# SALES ENGINEERING UPDATE

**RT2/RTE2-340, RT2/RTE2, RS, R  
400/460/480/520 & U2/UE2/340**

**NO:** SEU-9903

**SUBJECT:** Model Designation and  
Discontinuance

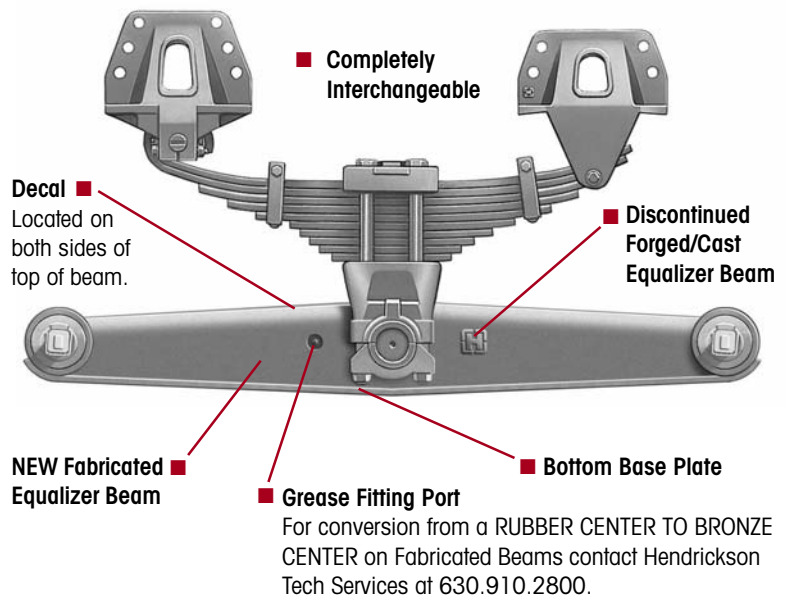
This model change is driven by the release of the new lighter weight fabricated equalizing beam as shown below. The beam is completely interchangeable with the old Forged/Cast beam. The new beam design is for use up to 46,000 lbs. and will be phased in between August 1999 and March 2000.

IT IS VERY IMPORTANT THAT THE ORIENTATION OF THE BEAM BE IN THE UPRIGHT POSITION. A DECAL IS AFFIXED TO THE TOP OF BEAM TO ASSIST IN ASSEMBLY AND TO VERIFY ORIENTATION. FAILURE TO ASSEMBLE EQUALIZER BEAM IN THIS MANNER MAY RESULT IN THE LOSS OF VEHICLE CONTROL AND POSSIBLE PERSONAL INJURY OR PROPERTY DAMAGE.
